Agenda Item # 10

SUB-002957-2024

Thomas Addition Subdivision

- Subdivision approval to create one (1) legal lot of record from one (1) metes-and-bounds parcel.

DETAIL SITE PLAN

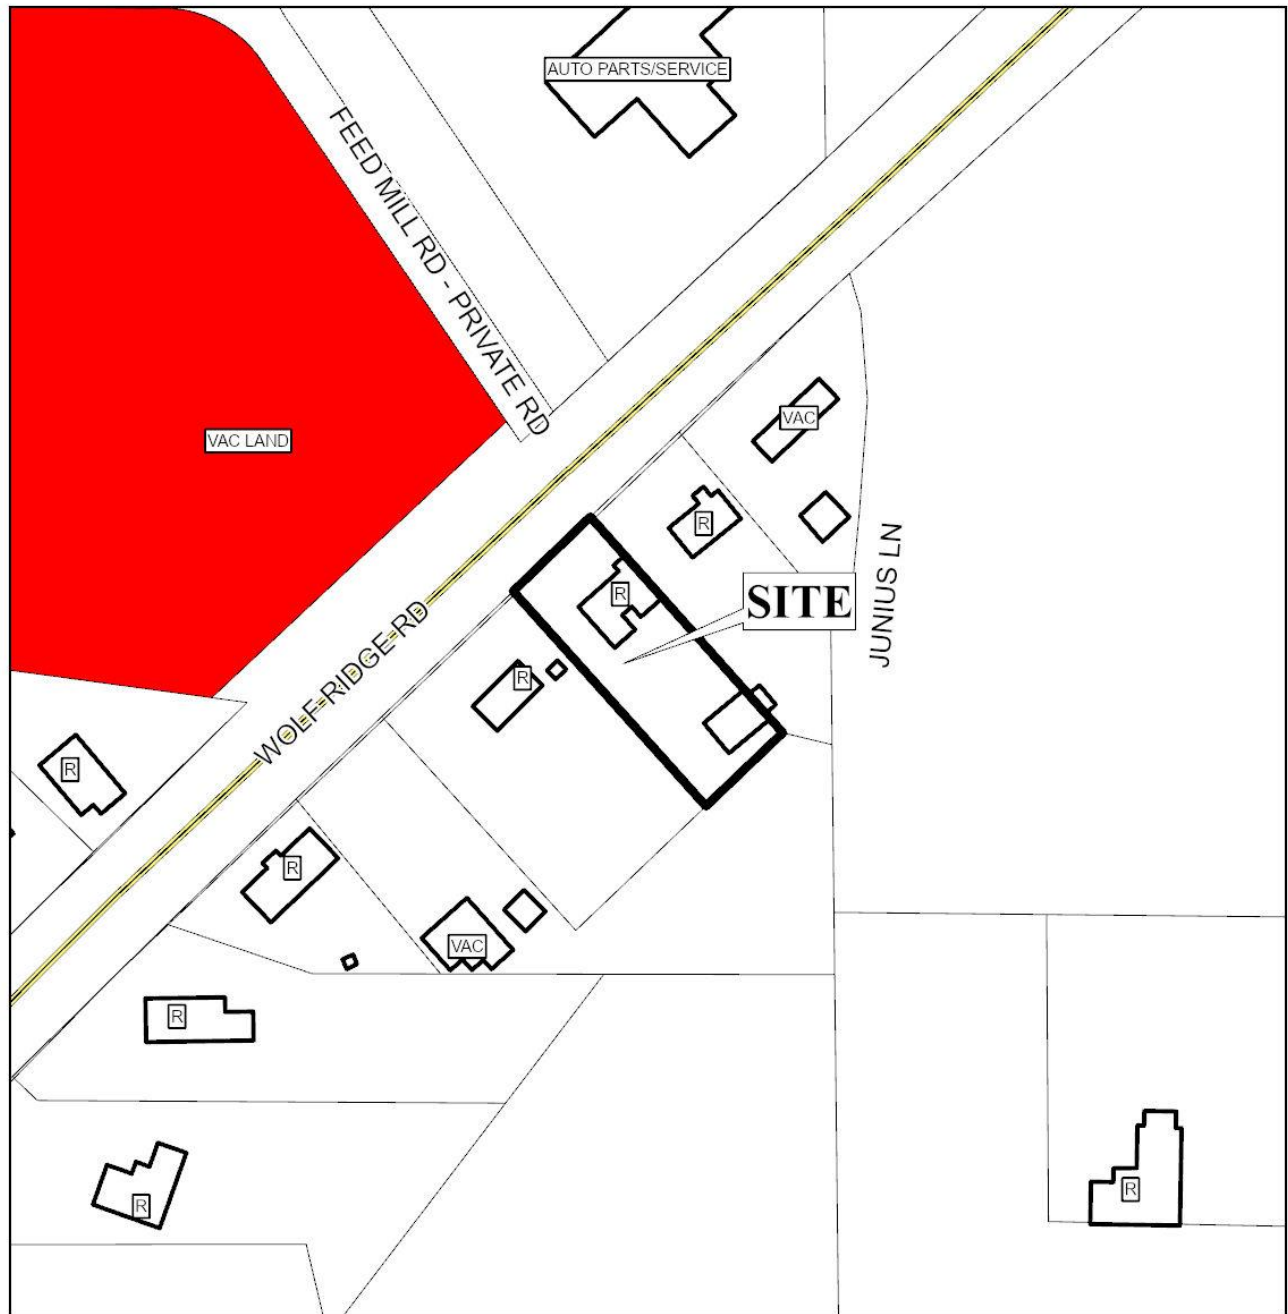
The site has frontage on Wolf Ridge Road, a Minor Arterial, open-ditch roadway requiring a 100-foot right-of-way width. The preliminary plat depicts a 70-foot right-of-way width at this location. Previous subdivision of the site across the street in 2011 required dedication sufficient to provide 50 feet from the centerline of Wolf Ridge Road, therefore it may be appropriate to require additional dedication of the subject site. It should be noted, however, that GIS maps indicate a 70-foot right-of-way width is common along Wolf Ridge Road. If approved, dedication sufficient to provide 50 feet from the centerline of Wolf Ridge Road should be required unless a waiver of Section 6.B.9. is granted by the Planning Commission.

The lot, as proposed, exceeds the minimum size requirements for lots served by public water and sanitary sewer in an R-1 Suburban district and is appropriately labeled in square feet and acres on the survey. If approved, this information should be retained on the Final Plat, adjusted for any required dedication; or placement of a table on the Final Plat with the same information will suffice.

A 25-foot front yard setback is illustrated along Wolf Ridge Road on the survey, in compliance with Section 64-2-5.E. of the Unified Development Code (UDC) for lots in the R-1 Suburban district. If approved, this information should be retained on the Final Plat, adjusted for any required dedication.

Five (5)-foot side yard setbacks and an eight (8)-foot rear yard setback are illustrated along side and rear property lines, which is not required by the Subdivision Regulations. As such, removal of the side and rear setbacks from the Final Plat should be required.

1. Revision of the plat to illustrate dedication sufficient to provide 50 feet from the centerline of Wolf Ridge Road, or Planning Commission approval of a waiver of Section 6.B.9. of the Subdivision Regulations;

2. Retention of the lot's size in square feet and acres on the Final Plat, adjusted for any required dedication, or provision of a table on the Final Plat with the same information;

3. Retention of the 25-foot minimum front yard setback along Wolf Ridge Road on the Final Plat, adjusted for any required dedication;
4. Removal of the side and rear yard setback lines from the Final Plat;
